**Household and similar electrical appliances – Safety –
Part 2-24: Particular requirements for refrigerating appliances, ice-cream
appliances and ice-makers**

IEC 60335-2-24 Amendment 2 to
Edition 7.0 2017-04

**Part 2-24: Particular requirements for refrigerating appliances,
ice-cream appliances and ice makers**

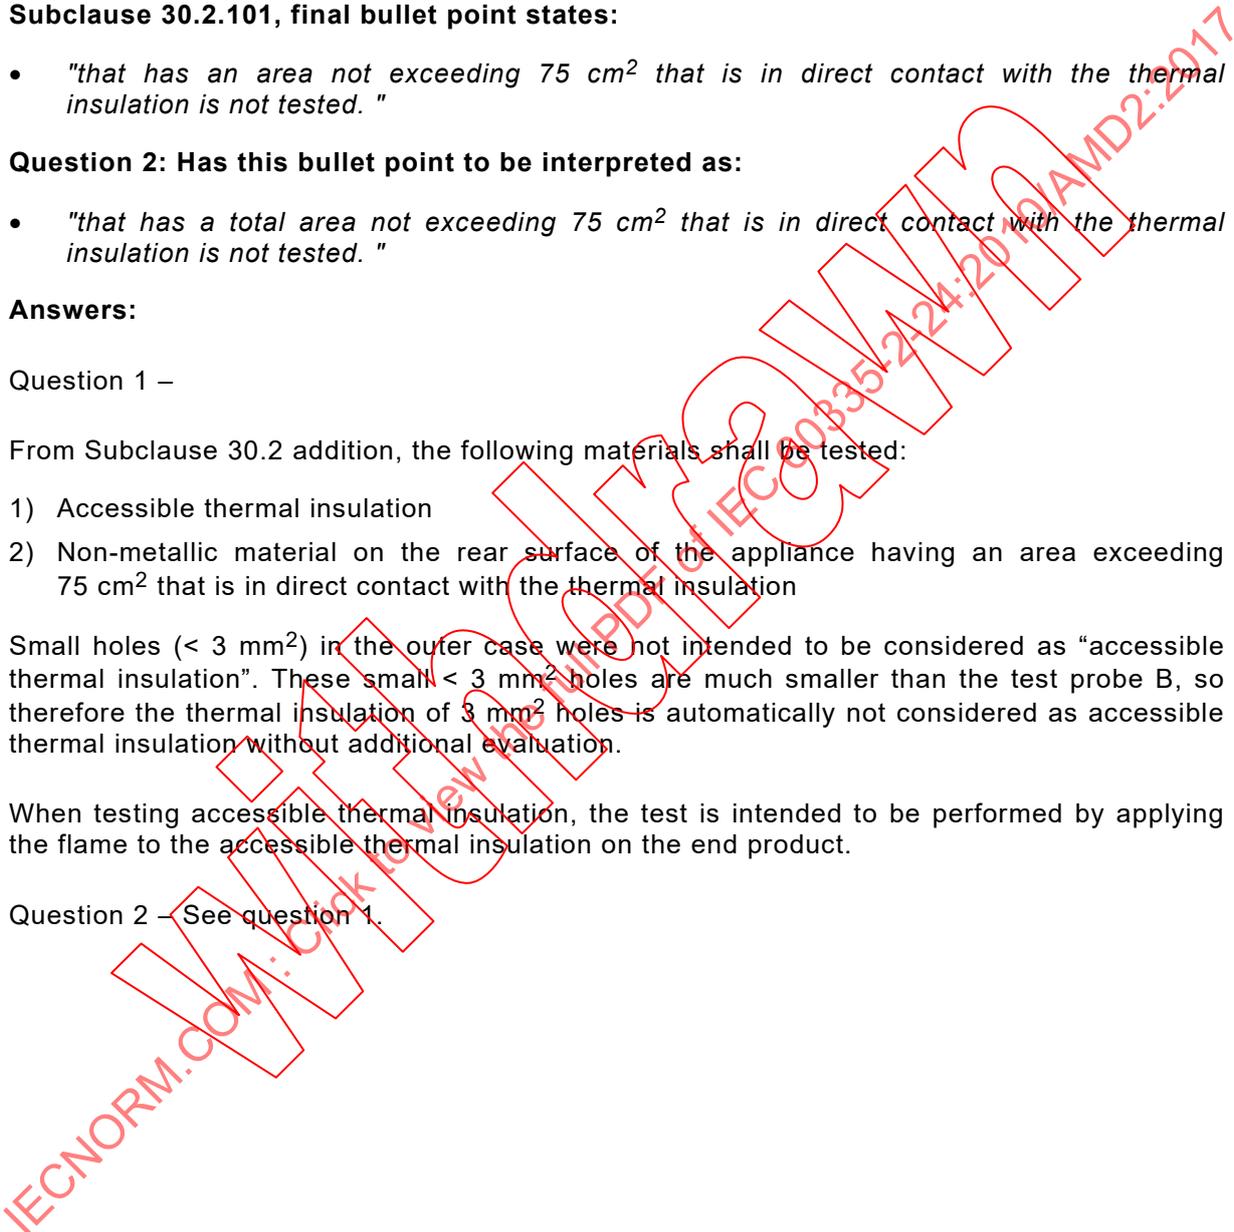
Question 2: Has this bullet point to be interpreted as:

- *"that has a total area not exceeding 75 cm² that is in direct contact with the thermal insulation is not tested. "*

- 1) Accessible thermal insulation
- 2) Non-metallic material on the rear surface of the appliance having an area exceeding 75 cm² that is in direct contact with the thermal insulation

Small holes (< 3 mm²) in the outer case were not intended to be considered as "accessible thermal insulation". These small < 3 mm² holes are much smaller than the test probe B, so therefore the thermal insulation of 3 mm² holes is automatically not considered as accessible thermal insulation without additional evaluation.

When testing accessible thermal insulation, the test is intended to be performed by applying the flame to the accessible thermal insulation on the end product.
